Mahler Water Reclamation Facility (MWRF) Interim Improvements

ADDENDUM NO. 3

INTERIM IMPROVEMENTS PROJECT

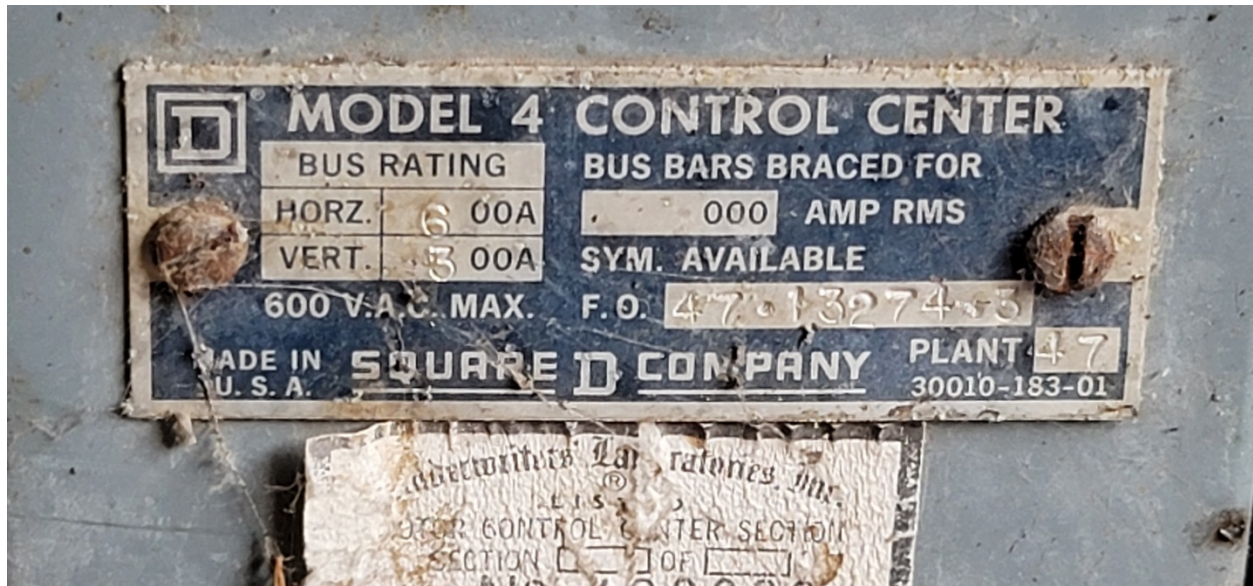
Q5. Can you please confirm material type & finish of the contractor supplied steel conveyor supports. Per note on sheet S-010 it calls for carbon steel HDG but 05 10 00 lists carbon steel and stainless steel.

A. Carbon steel, hot-dip galvanized after fabrication.

SHEET
I-253
40 of 42

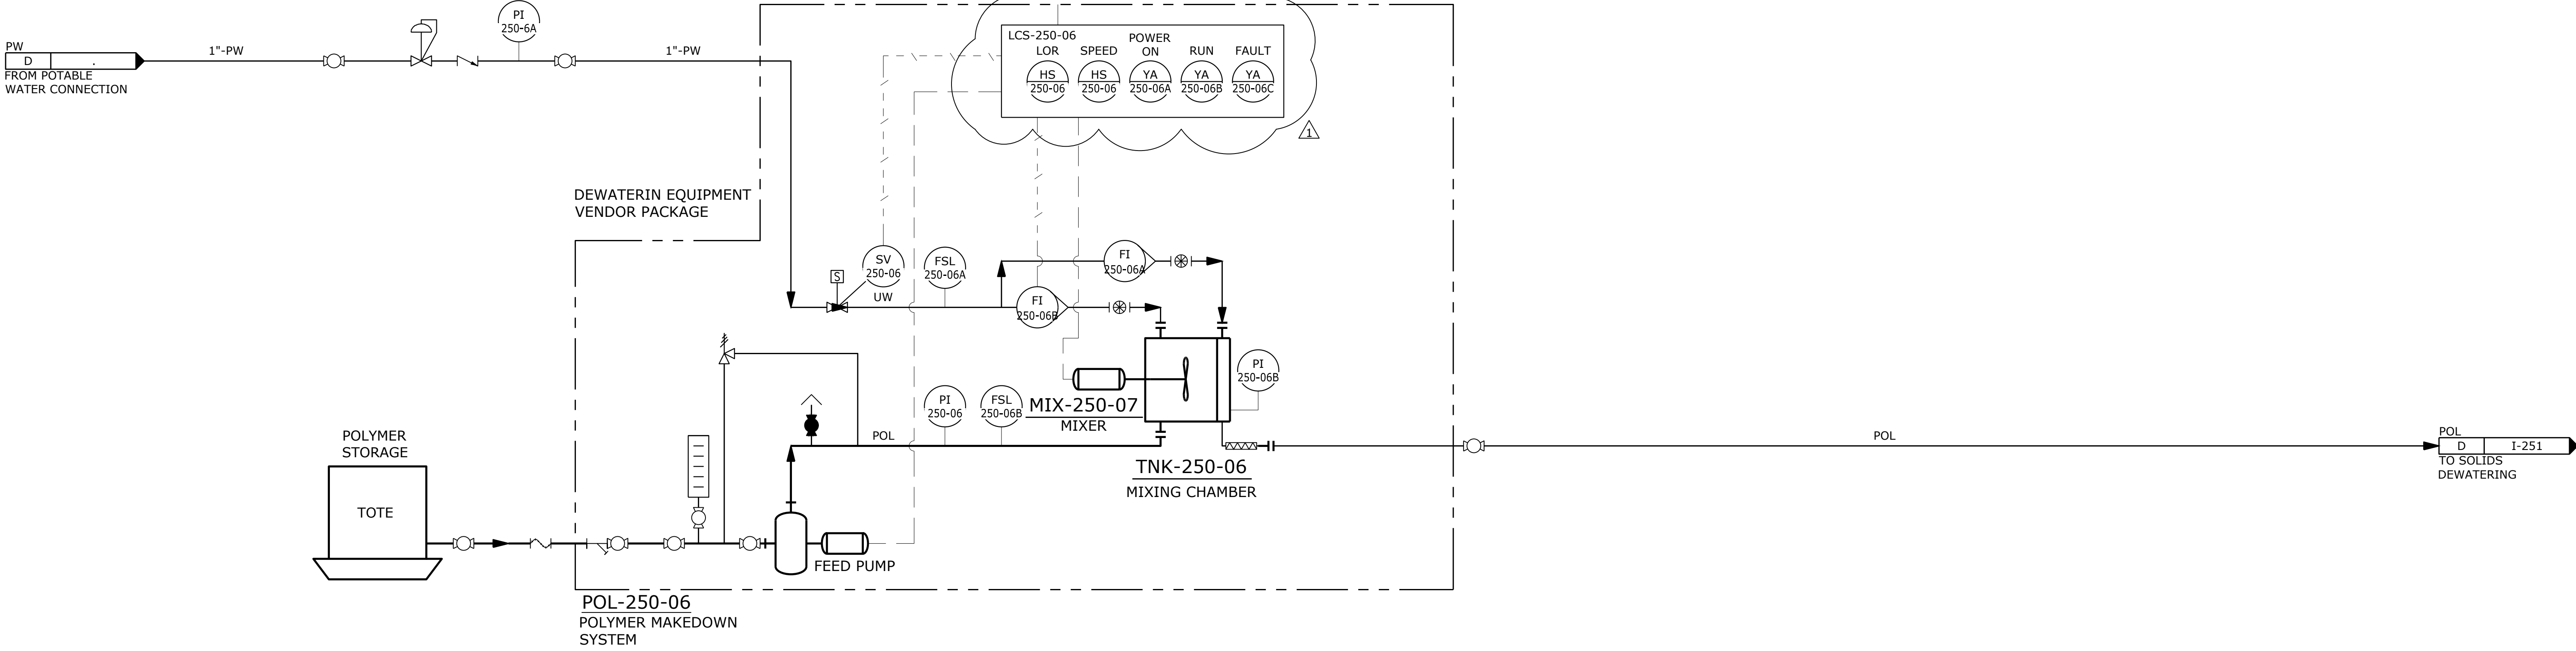
△	02/2023	HB/MB	ADDENDUM #3
△			
△			
△			
△			
△			
NO.	DATE	BY	REVISION
